ADDENDUM NO. 2

NOTICE TO BIDDERS OF PROJECT NO. 20223 RAY WILLIAMSON POOL IMPROVEMENTS – PHASE 1

Bainbridge Island Metro Park & Rec District: Ray Williamson Pool Improvements

PROJECT ARCHITECT
PROJECT MANAGER
DRAWN
FIRE PROTECTION ROOF PLAN

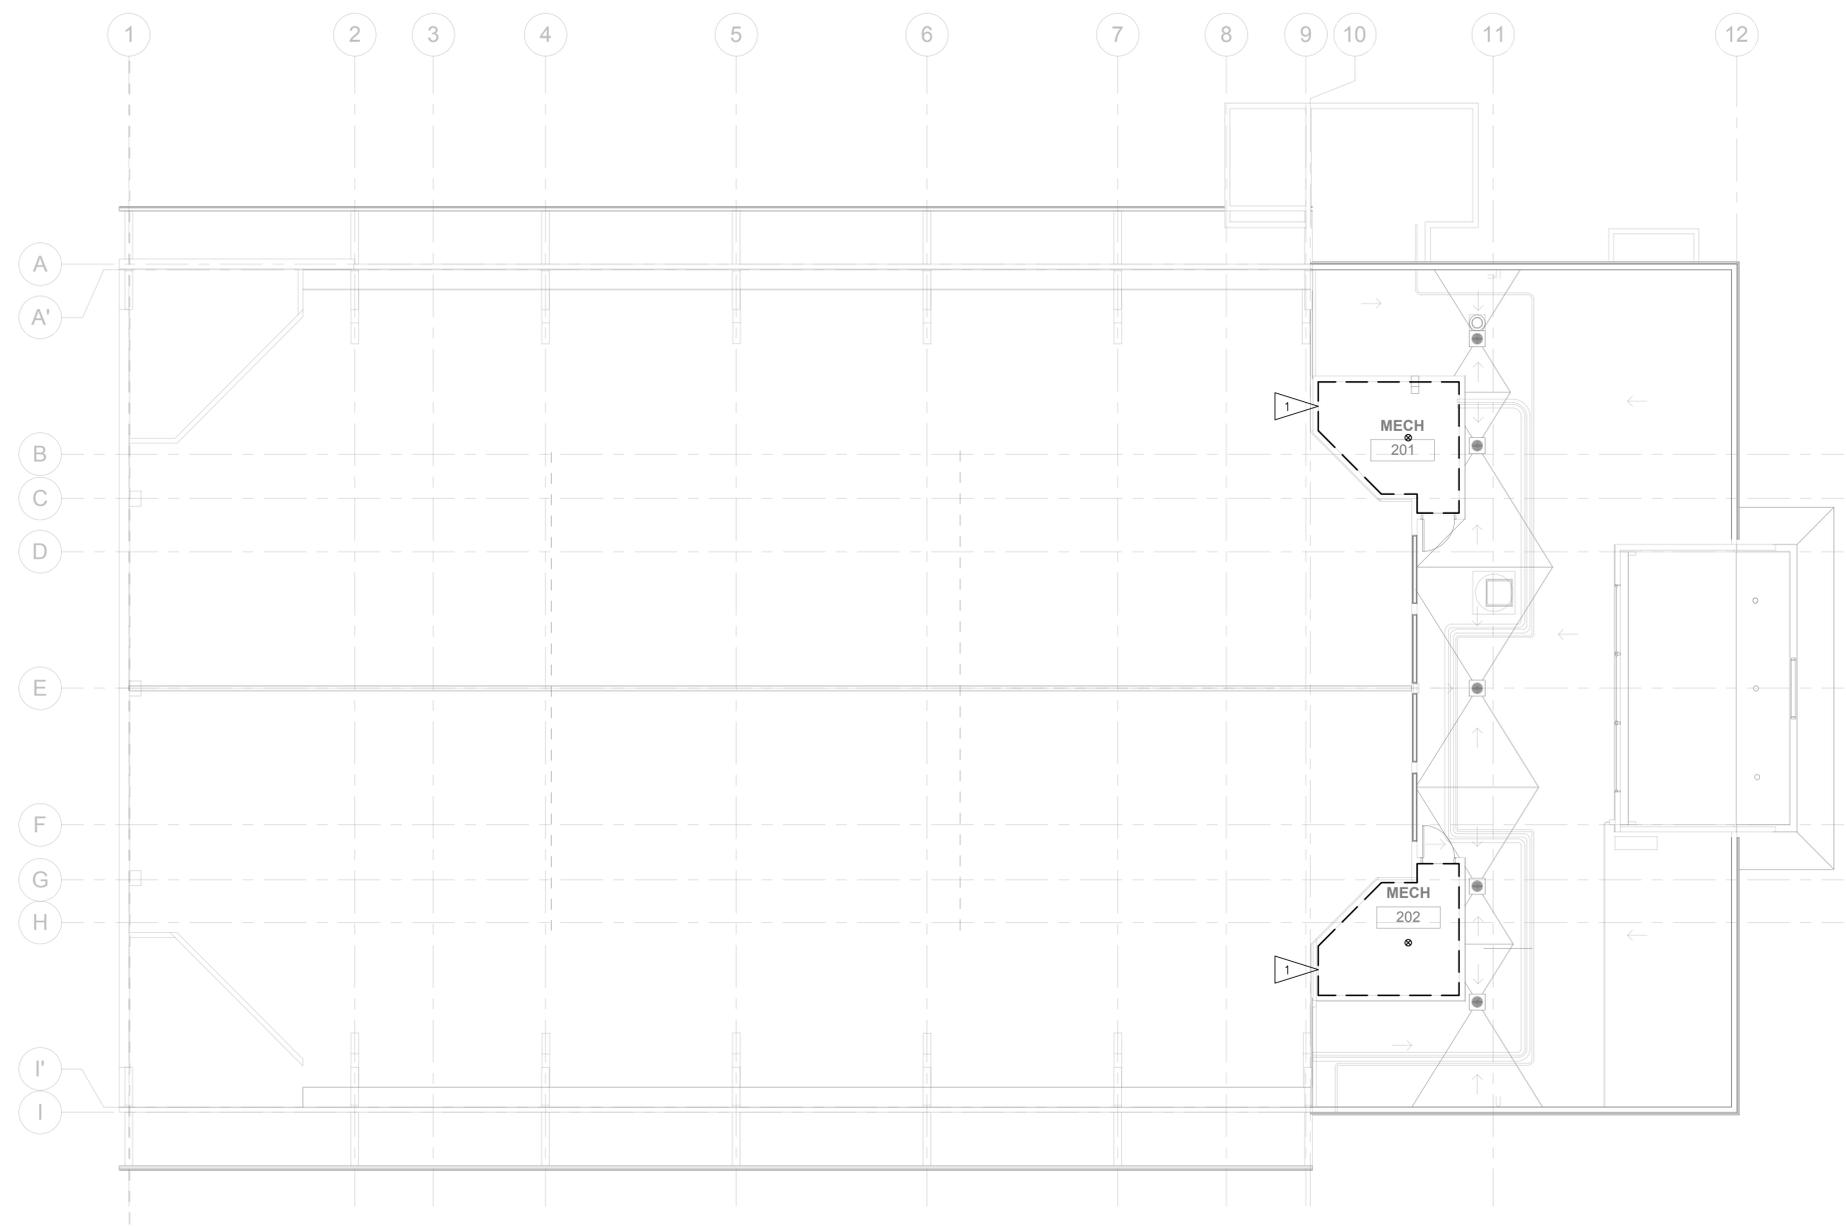
3. **DELETE** sheet F1.1 Fire Protection Roof Plan and **REPLACE** with sheet F1.1 Fire Protection Roof Plan in its entirety, attached in Addendum No. 2.

DELETE keynote No. 2 on Sheet Keynotes and **REPLACE** with keynote No. 2.

ALL NEW SPRINKLERS AND SPRINKLER PIPE IN THIS AREA. PAINT FOR CORROSION PROTECTION PRIOR TO COVER.
